From: May Downing <mdowning@doc.govt.nz>
Sent: Tuesday, 24 April 2018 12:48 PM
To: 'jon.williamson@wwa.kiwi'; Alissa Sluys; 'chrisrjsimpson@gmail.com'; 'brydon@landwaterpeople.co.nz'; Catherine Reaburn
Cc: Blyth, James; Jacob Williams; 'Baker, Tim'; Shona Myers
Subject: DOC's comments on the GMCP and conditions
Attachments: MWWUG_GMCP_rev2 DOC Comments 24 April 2018.docx

Please find attached the Department's comments on the updated draft GMCP provided on 16 April 2018. These have been prepared with the input of our experts: Shona Myers, Tim Baker and James Blyth.

Motutangi-Waiharara Water Users Group

Groundwater Management and Contingency Plan

Figure 3. Overview diagram of the Contingency Plan.

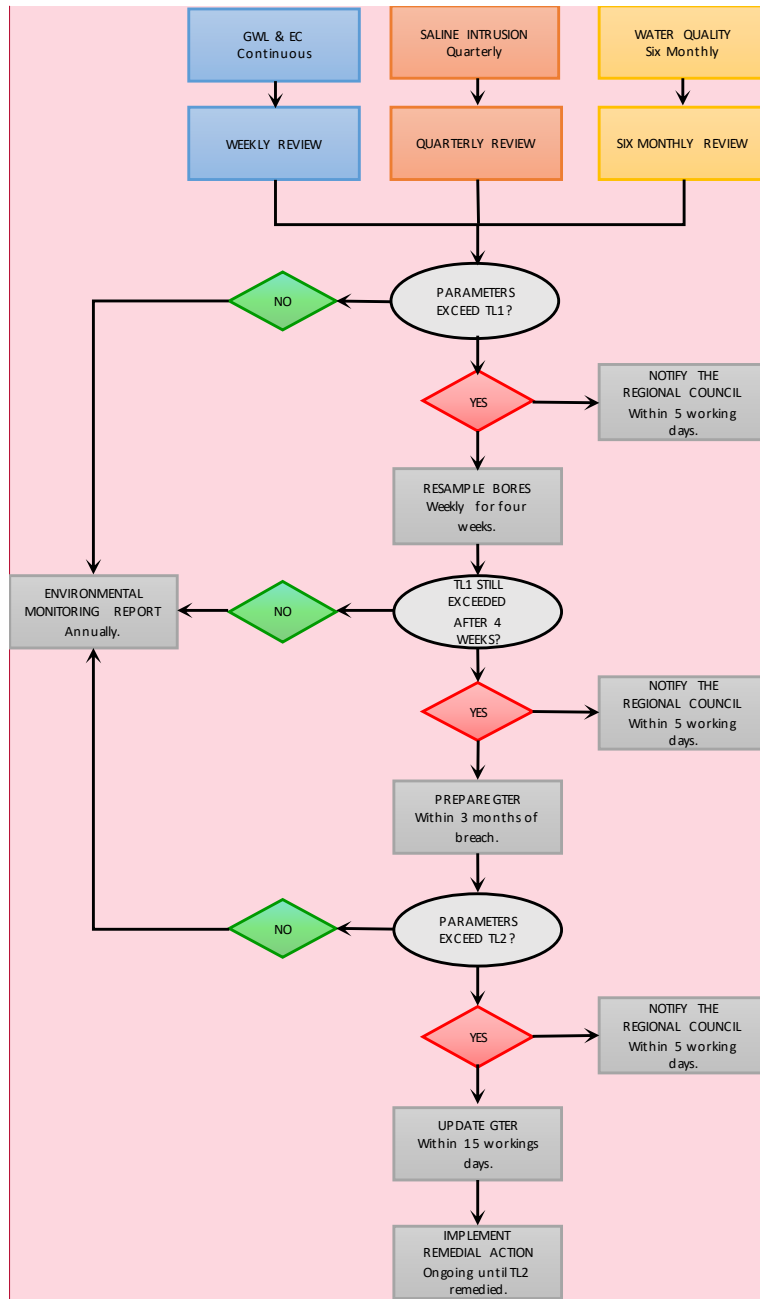
Commented [MD46]: Where does the monitoring plan provide for "weekly review"?

What if TL2 is exceeded at the outset?

Some boxes state to "notify the Regional Council within 5 working days" – 5 working days of what in particular?
